Comments on the Draft EIR

**FORMAL COMMENTS TO THE DRAFT ENVIRONMENTAL IMPACT REPORT
LODI GAS STORAGE PROJECT**

FIGURE 3.10-1

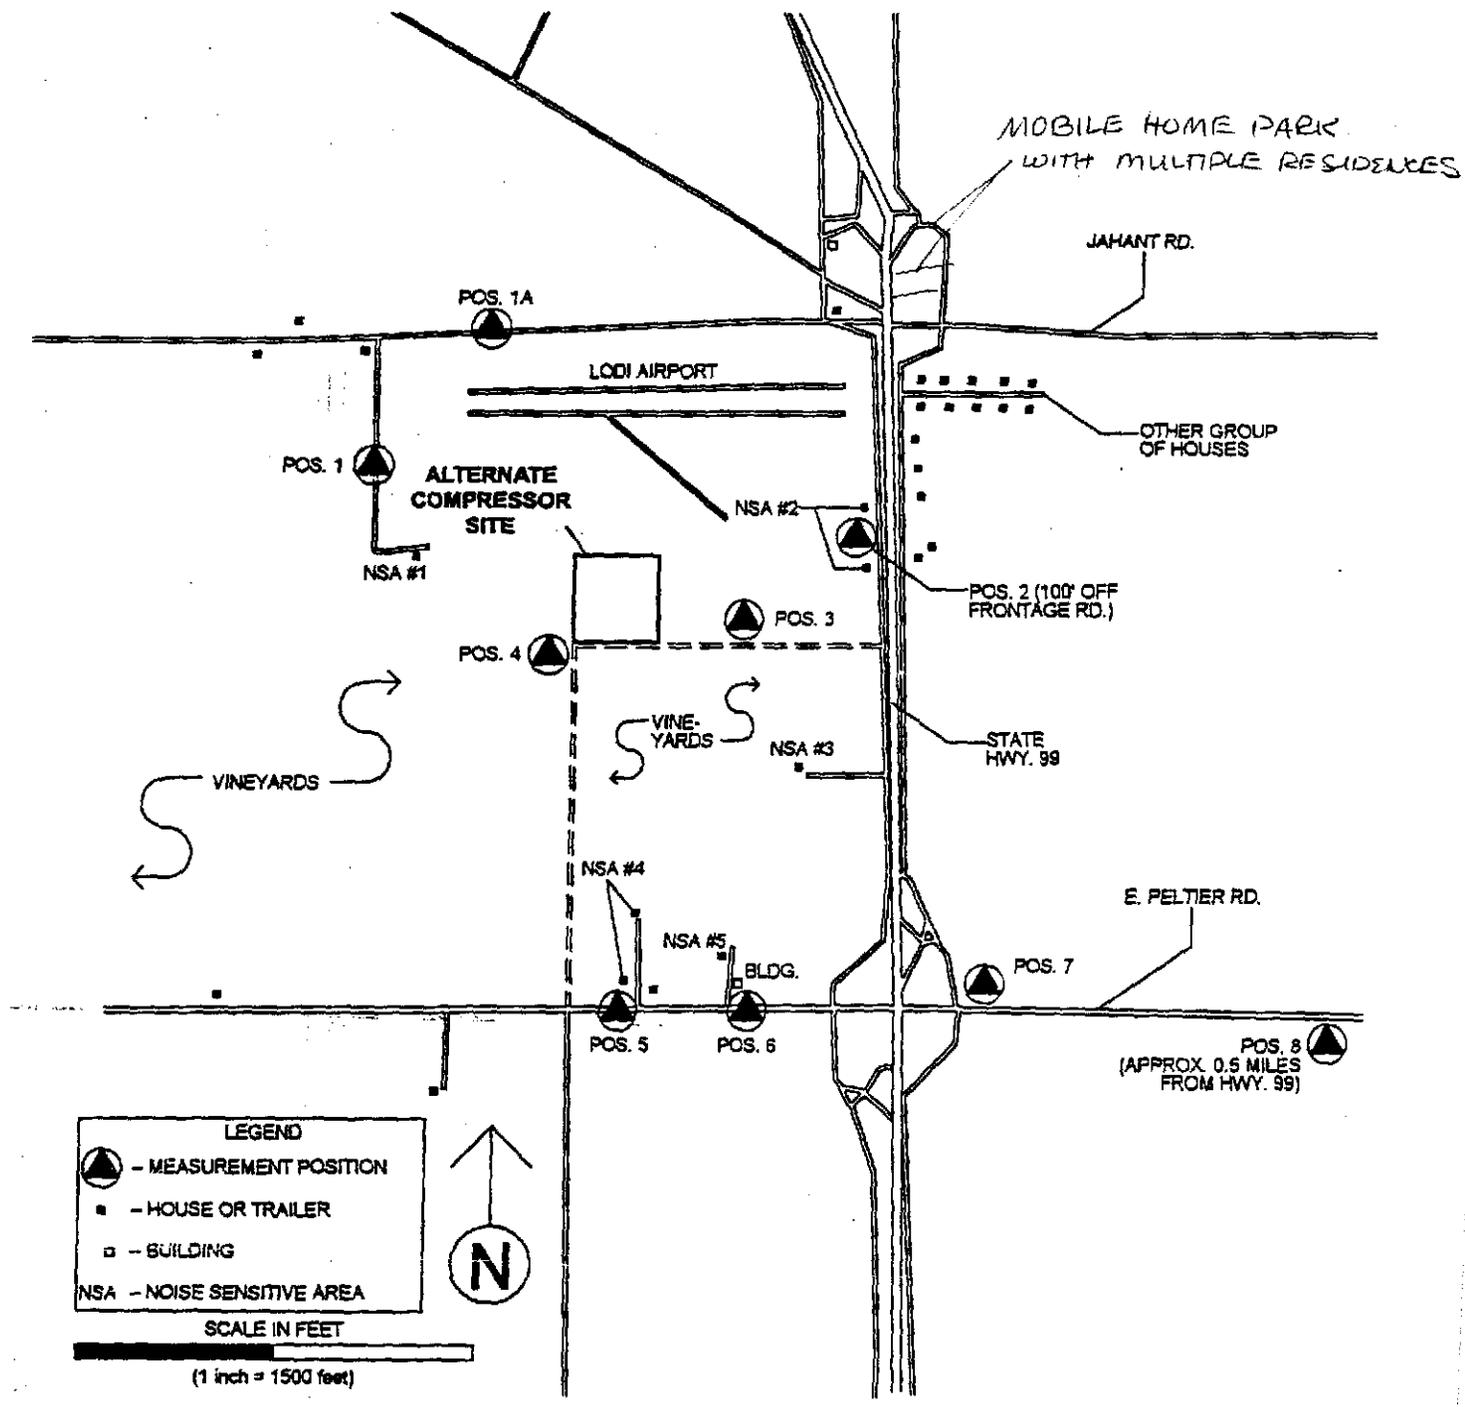
Attached also is a copy of Figure 3.10-1 with notations.

I19-3

- I19-3. Comment noted. The additional features described by the commenter are 3,000 feet or more from the alternative compressor site, well beyond the range of potential noise impact of project facilities. In addition, both residential areas are located nearer to Highway 99 and Lind Airport than to the compressor site.
